**CONTRACT HY/2009/15**

**CENTRAL – WAN CHAI BYPASS  
TUNNEL (CAUSEWAY BAY TYPHOON SHELTER SECTION)**

**Landscape Plan**

**Submission Status: For Approval**

# Report of Tree Preservation and Protection Plan with photos of retained trees

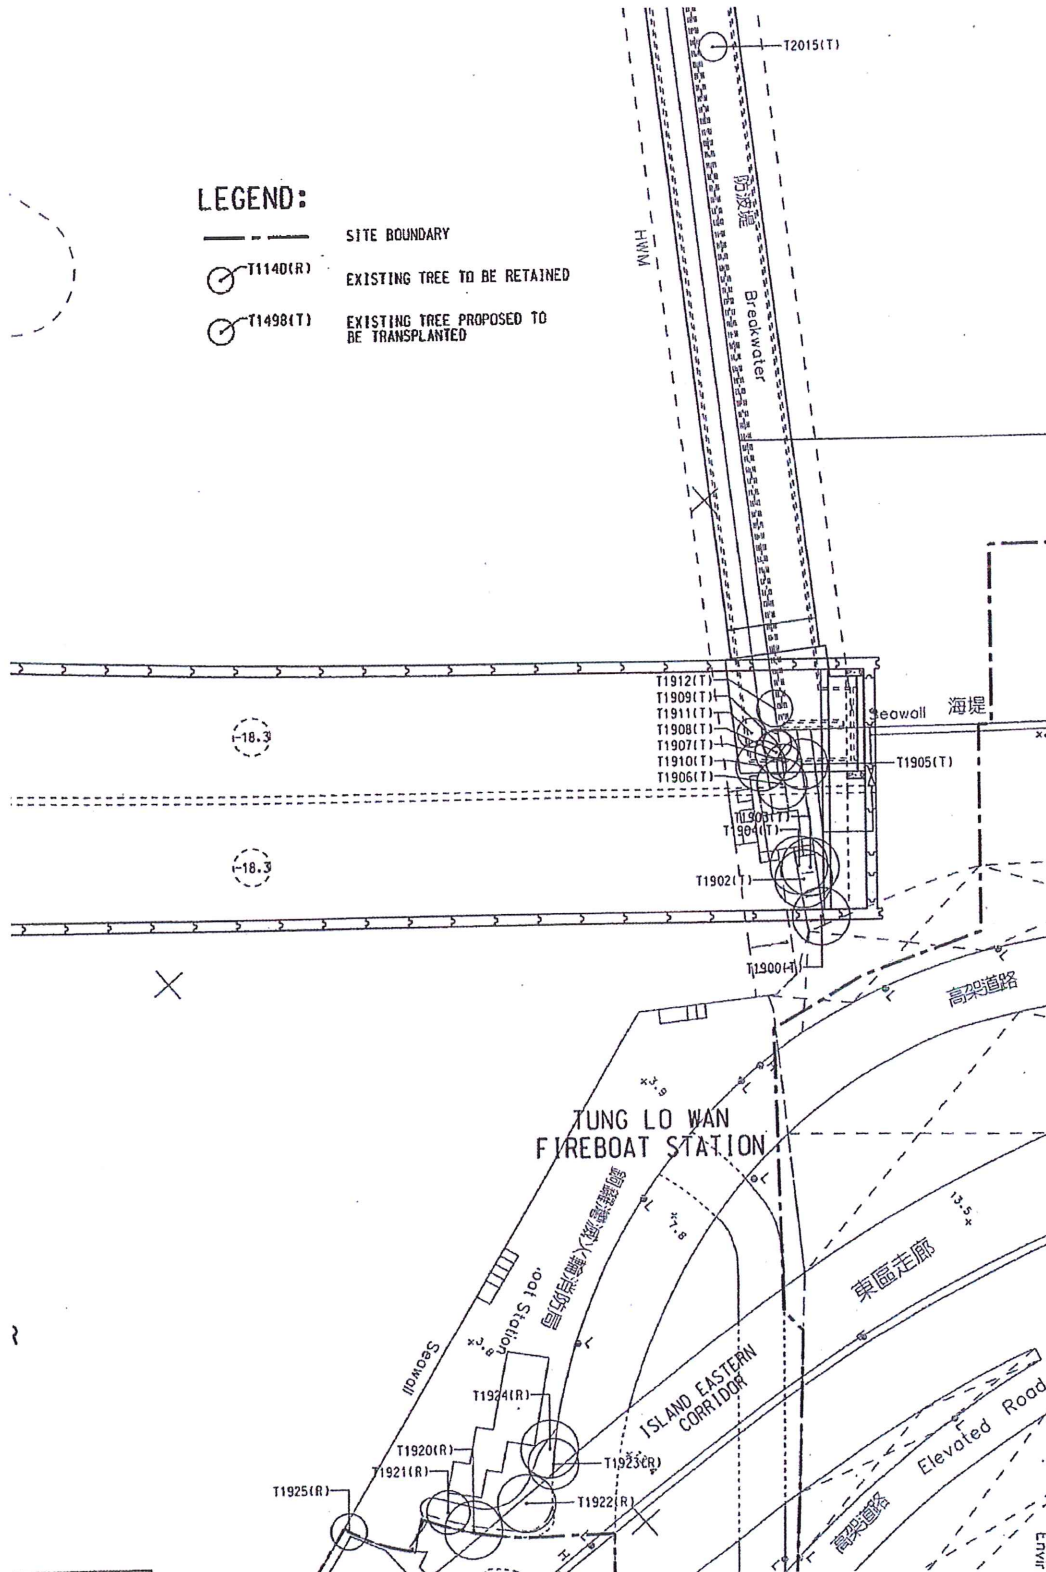
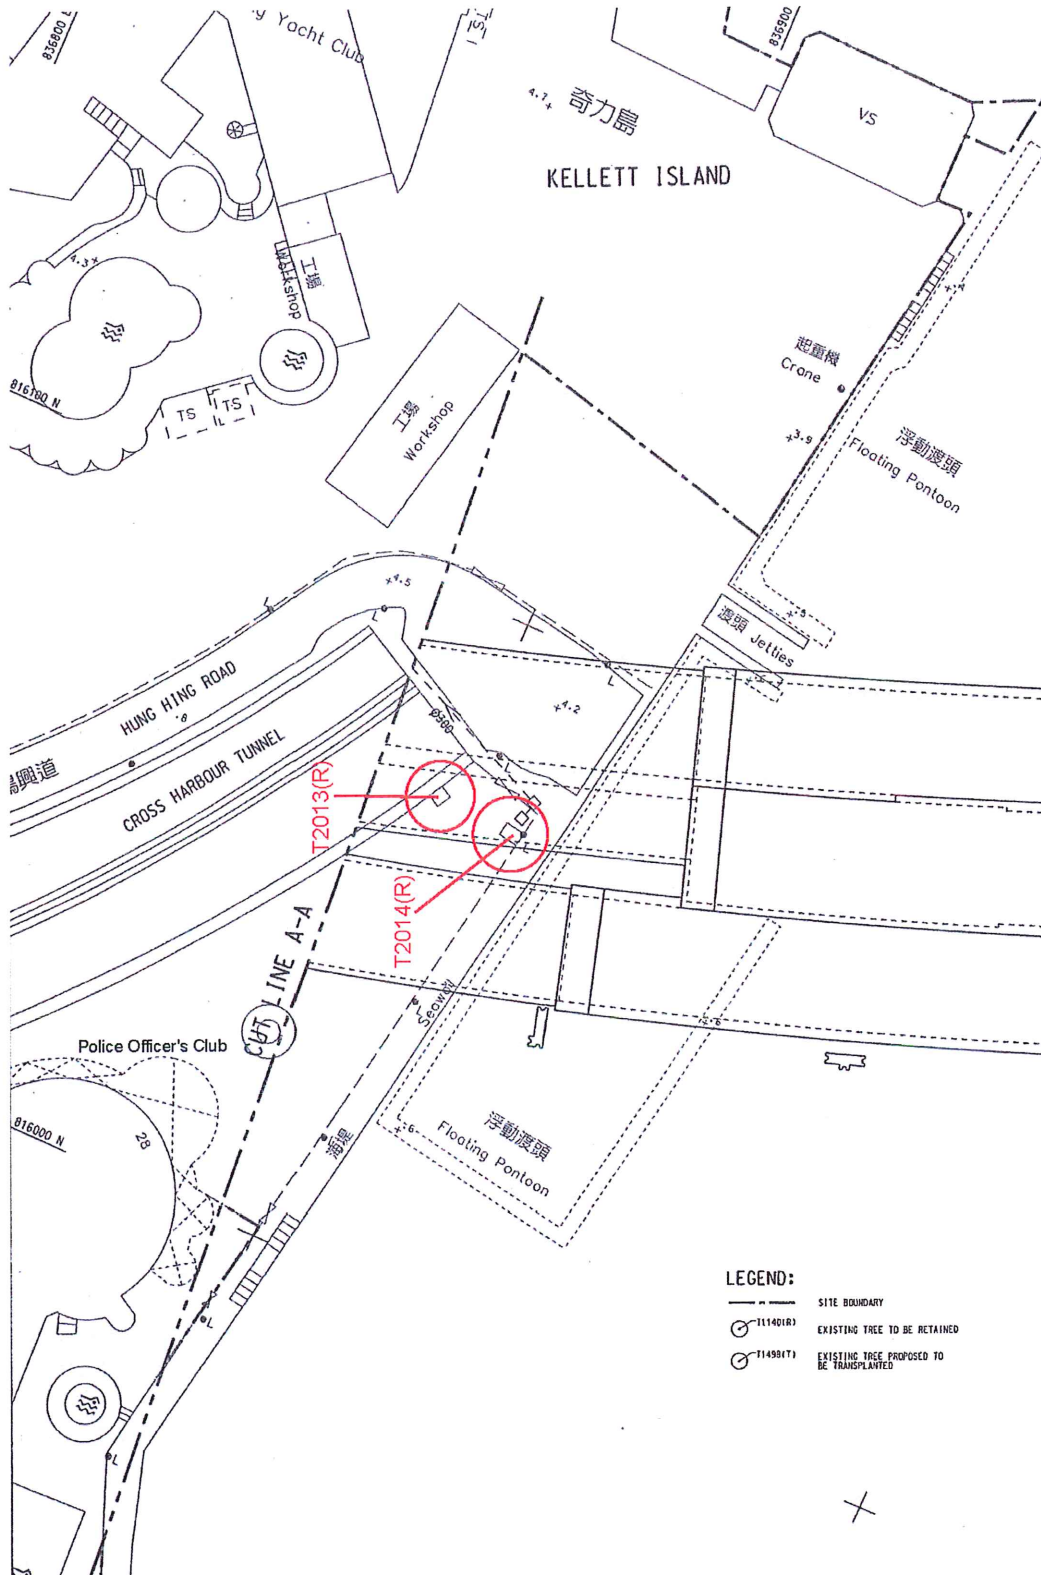
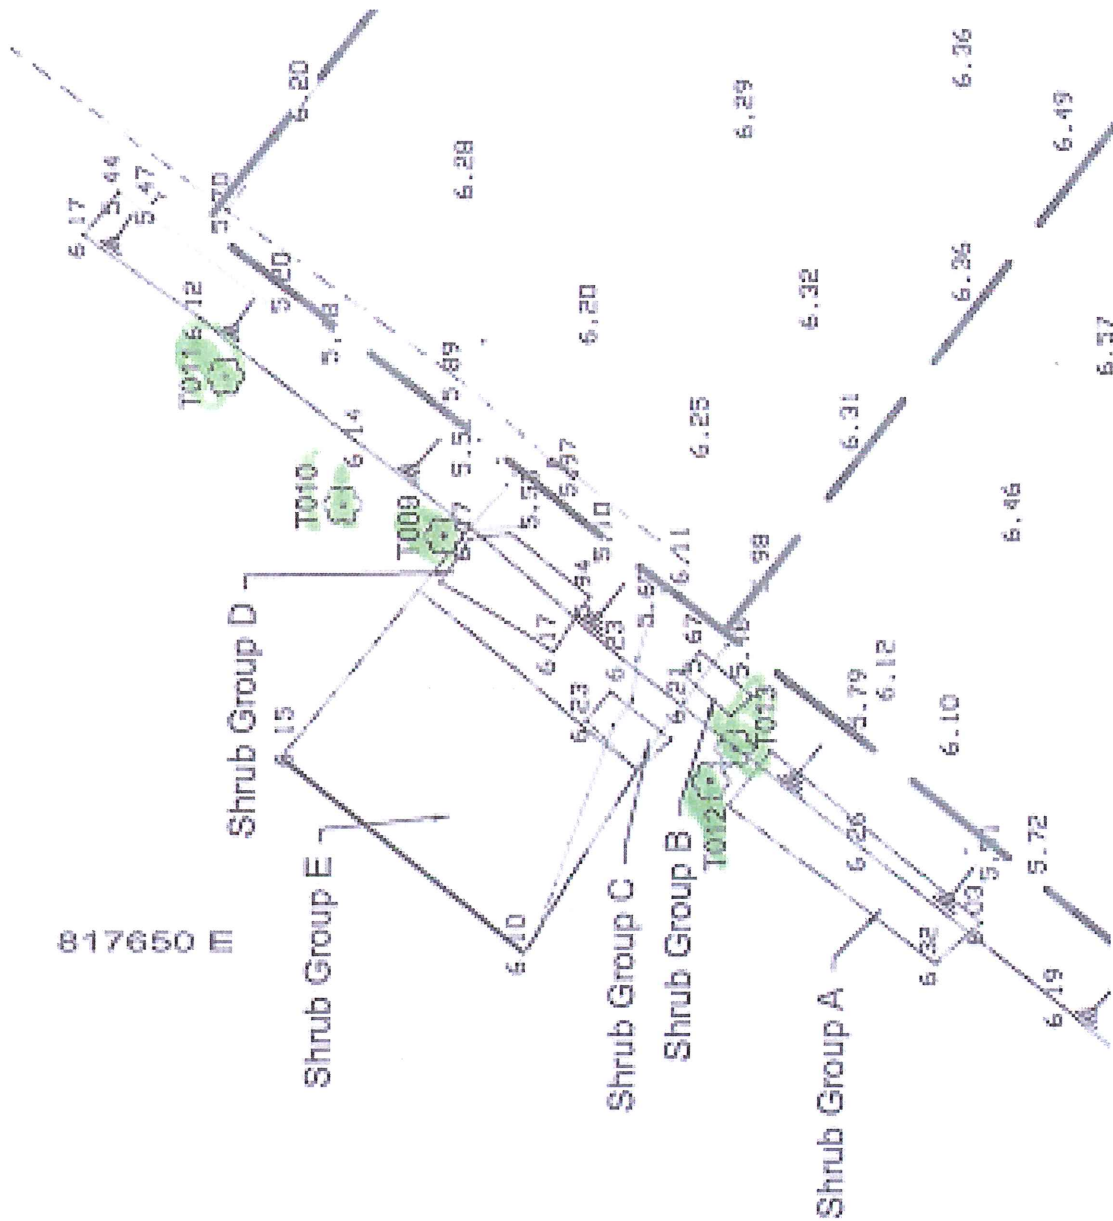
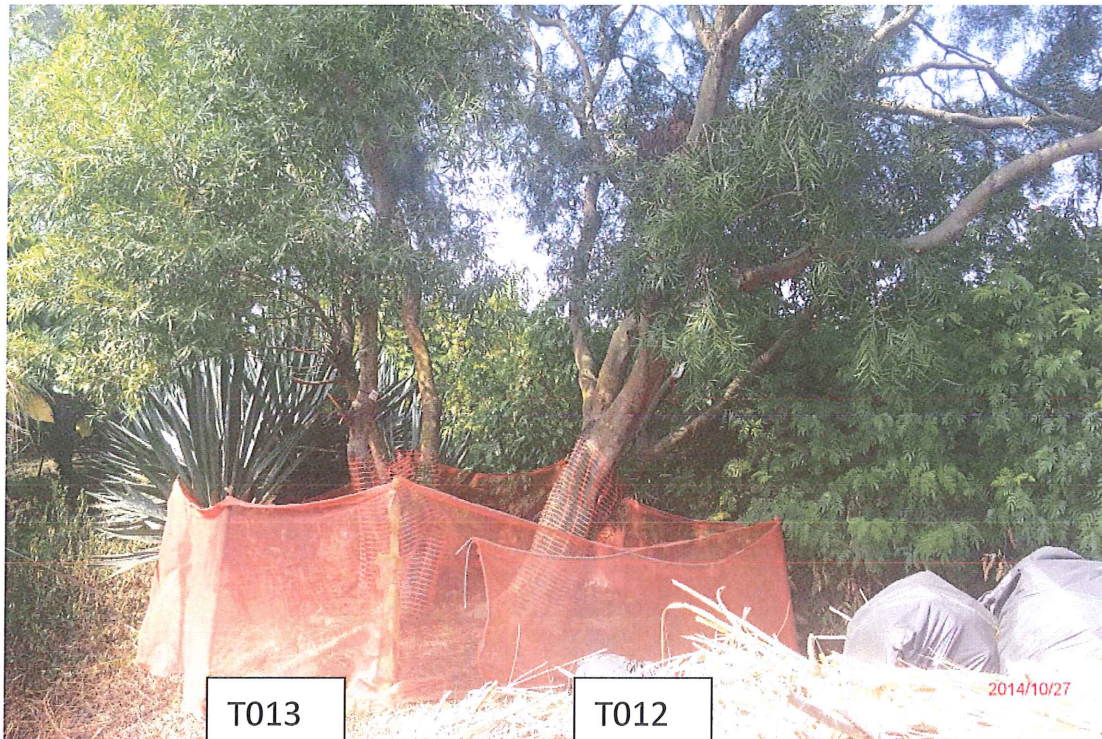
3	It is noted that all the tree record photos were taken on 10.10.2013 which are outdated. More recent tree record photos should be provided instead.	Appendix H & I has been updated.

### Permanent Location of Dead Trees T1906 & T1907

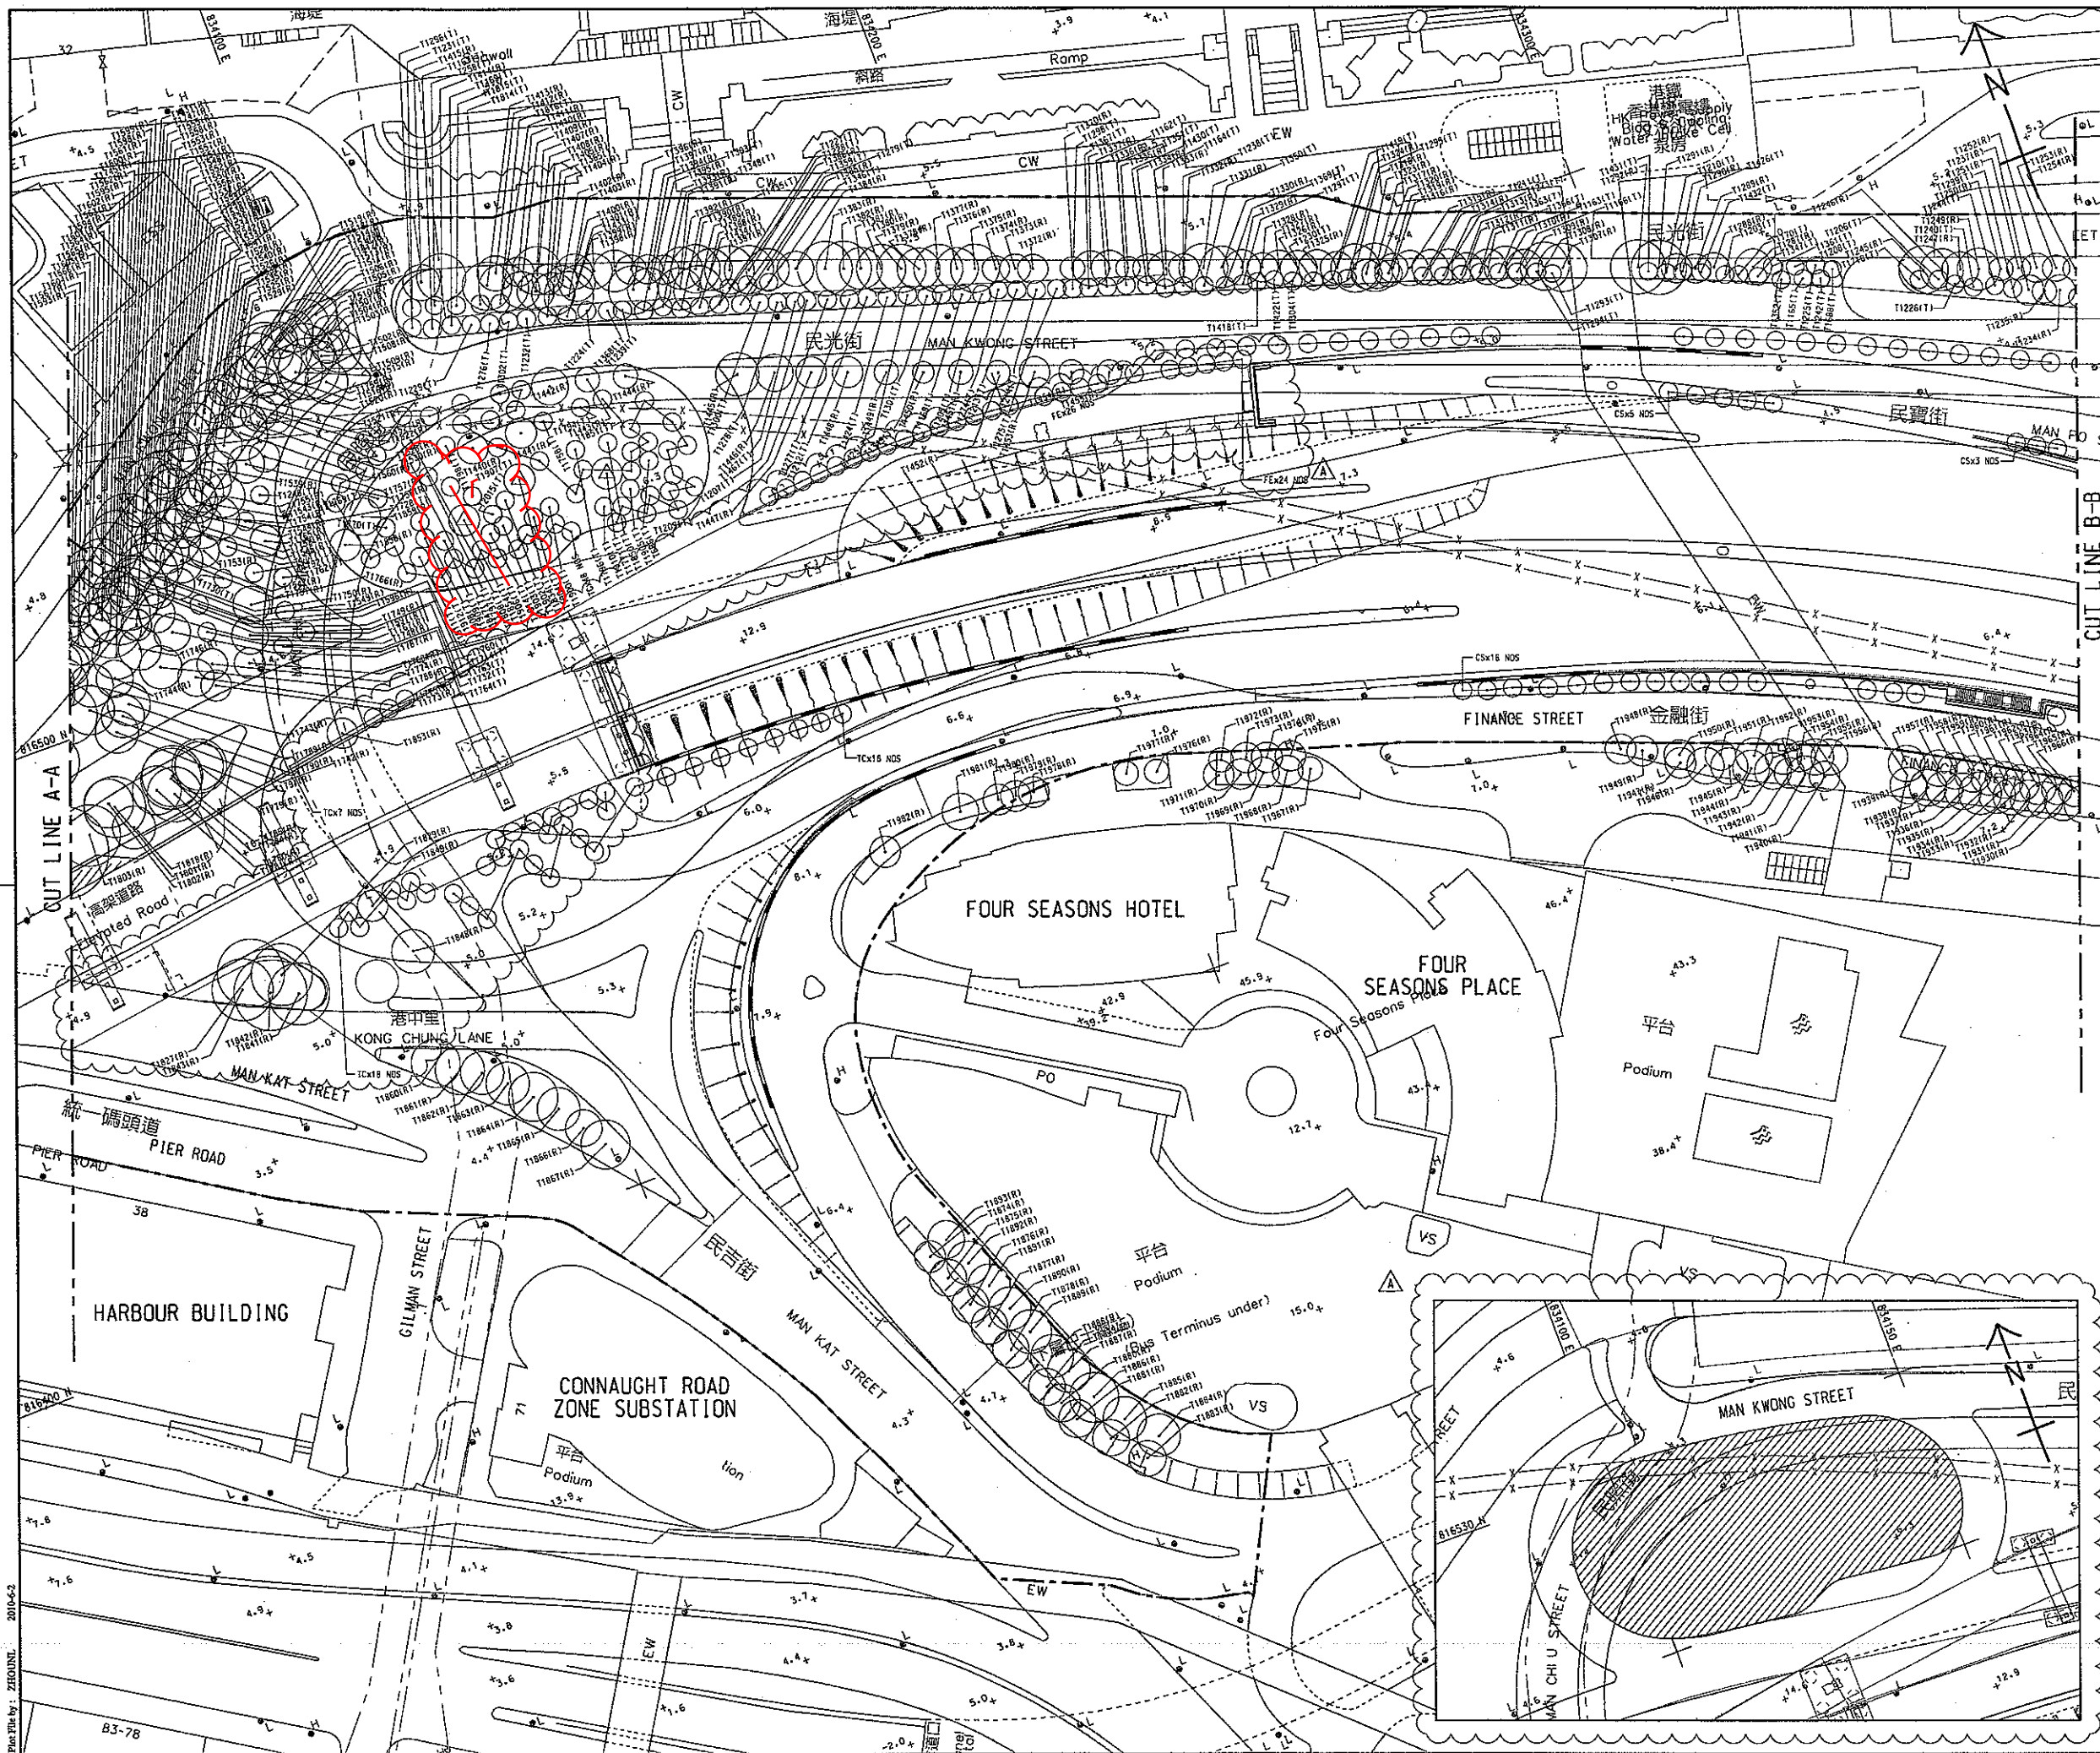
Ref	Comments	Responses
Comments from EPD		
1	Please be advised that ETWB TC(W) No.3/2006 has been superseded by DEVB TC(W) No. 10/2013. Please update all the references in the submission.	Section 9 & 10 have been updated.
2	Details of the compensatory tree planting for the 4 dead trees, T1905, T1906, T1907 and T1909, such as proposed species, sizes, quantity and future locations, according to the requirements as stipulated in DEVB TC (W) No. 10/2013 should be included in the Landscape Plan.	<p>Section 8 &amp; 10 has been revised.</p> <p>Please be informed that trees T1906 and T1907 will be compensated in accordance with the requirement as stipulated in DEVB TC(W) No. 10/2013 and the proposed species, sizes, quantity and future locations will be included in the Landscape Plan. For details, please refer to Table 1 of the revised Landscape Plan.</p> <p>An initial tree survey was carried out in November 2010 upon handover of the site, Tree T1909 and T1905 were found dead and damaged respectively. The condition of the trees was reported to LandsD and these trees were proposed to be felled in December 2010, please refer to the attached letter. Tree T1905 was subsequently fell down on 24 January 2011 and the incident was due to termite attack which resulted in less than 20% of sound wood remains. The incident report prepared by the Engineer' s Representative is also attached for easy reference. As the death of the trees was not caused by the works, we consider that compensation for the dead trees T1905 and T1909 was not required.</p>

accordance with the requirements of DEVB TC(W)No.10/2013. This being of a ratio not less than 1:1 in terms of the total numbers of aggregated girth size of compensatory trees and shall not be less than that of dead trees. The size of compensatory trees should be at least of “heavy standard”. (Please refer to Table 1 for details.) Compensatory trees will be planted in our holding nursery and will be transplanted to Central Interchange by Central-Wan Chai Bypass – Central Interchange (CWB(CI)). Please refer to Appendix J for the permanent location.
